UNITED STATES PATENT AND TRADEMARK OFFICE

| APPLICATION NO. | FILING DATE | FIRST NAMED INVENTOR | ATTORNEY DOCKET NO. | CONFIRMATION NO. |
|-----------------|-------------|----------------------|---------------------|------------------|
| 10/828,843 | 04/21/2004 | James A. Perkins | 56527.C1/ C-3670.0 | 5307 |

Office Action Summary

DETAILED ACTION

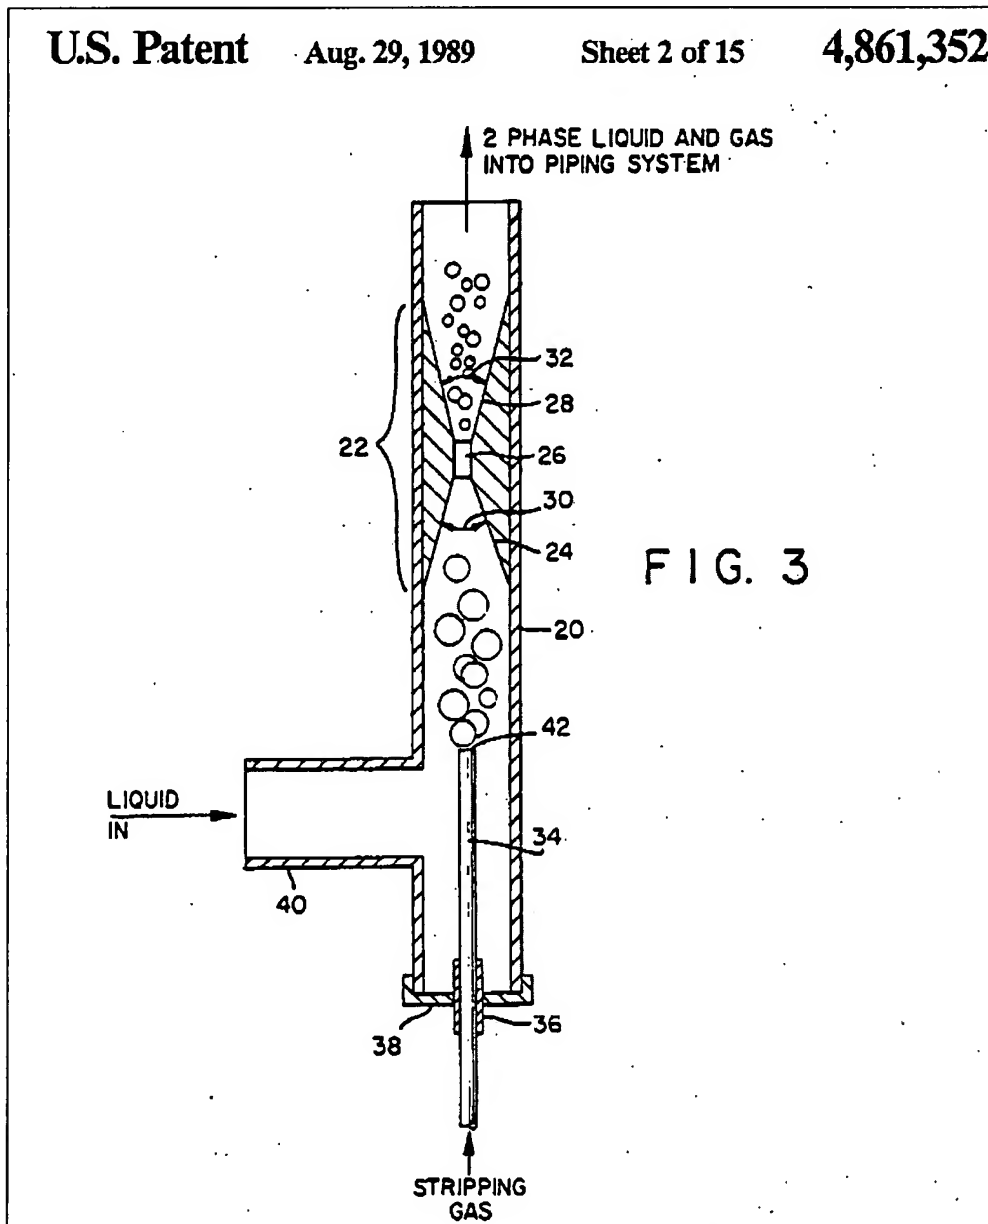
As shown in Fig. 1, Rentschler discloses a water remediation system.

The stripper of Rentschler is in the process flowline, and hence, ***"inline."***

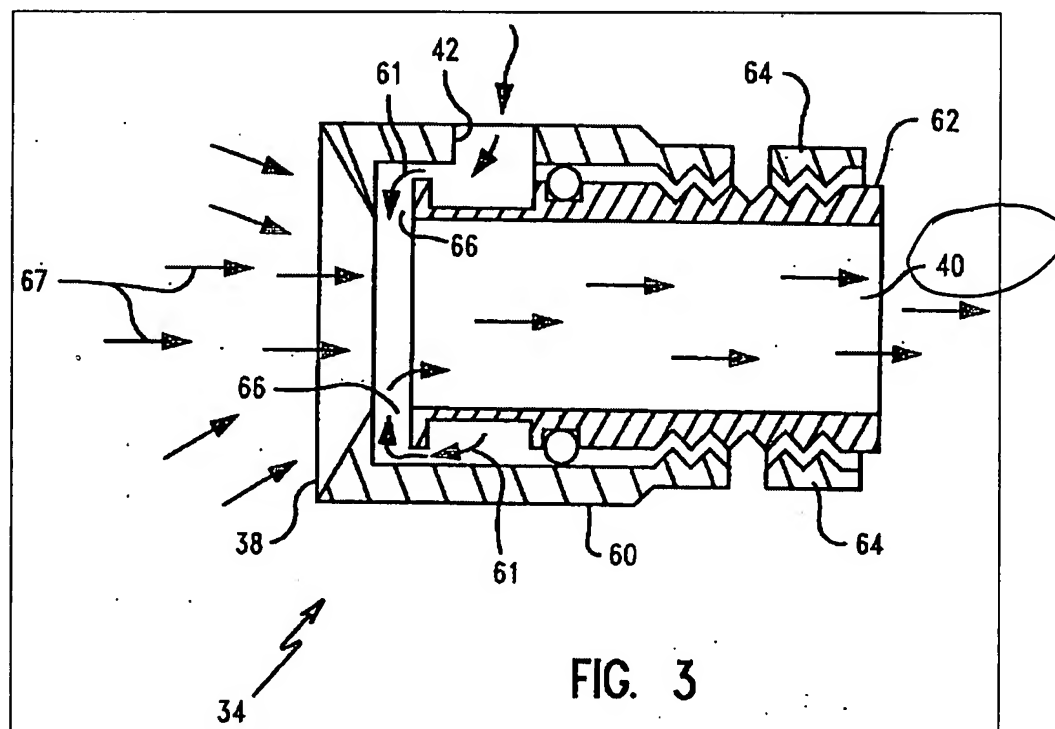
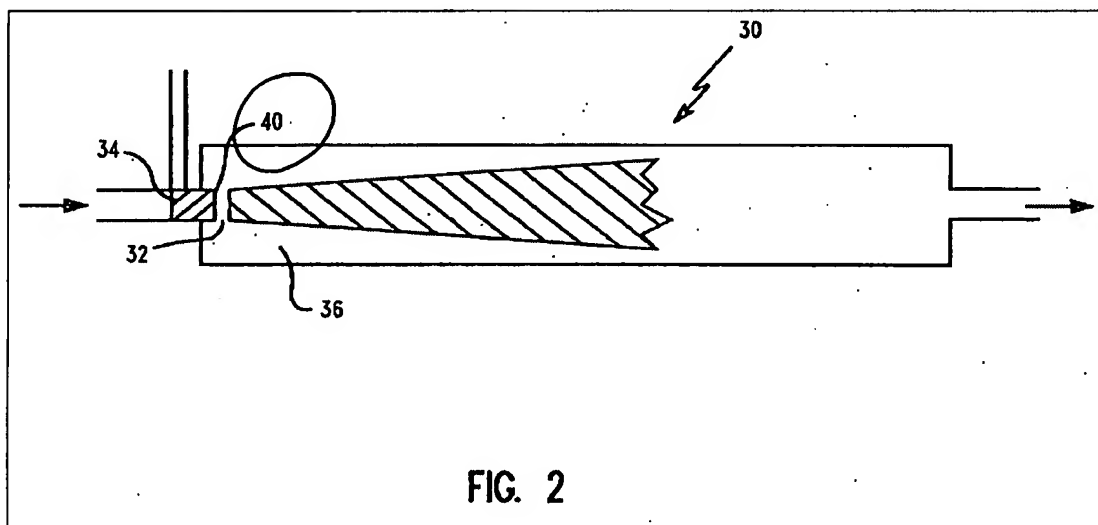
The changes to Fig. 1 are approved. The changes to Fig. 2 are not approved. Deletion of the cross-hatching makes the drawing more difficult to understand. Again, an arrow indicating the compressed air flow in Fig. 2 is missing.

The drawings are objected to because in Fig. 2, it is unclear what the cross-hatched shape in the chamber 36 is intended to represent (it should be labeled), and the flows into the air amplifier 34 need to be labeled with reference numerals. Also, it is unclear what Applicant intends by reference numeral 32 in Fig. 2.

Corrected drawing sheets in compliance with 37 CFR 1.121(d) are required in reply to the Office action to avoid abandonment of the application. Any amended replacement drawing sheet should include all of the figures appearing on the immediate prior version of the sheet, even if only one figure is being amended. The figure or figure number of an amended drawing should not be labeled as "amended." If a drawing figure is to be canceled, the appropriate figure must be removed from the replacement sheet, and where necessary, the remaining figures must be renumbered and appropriate changes made to the brief description of the several views of the drawings for consistency.
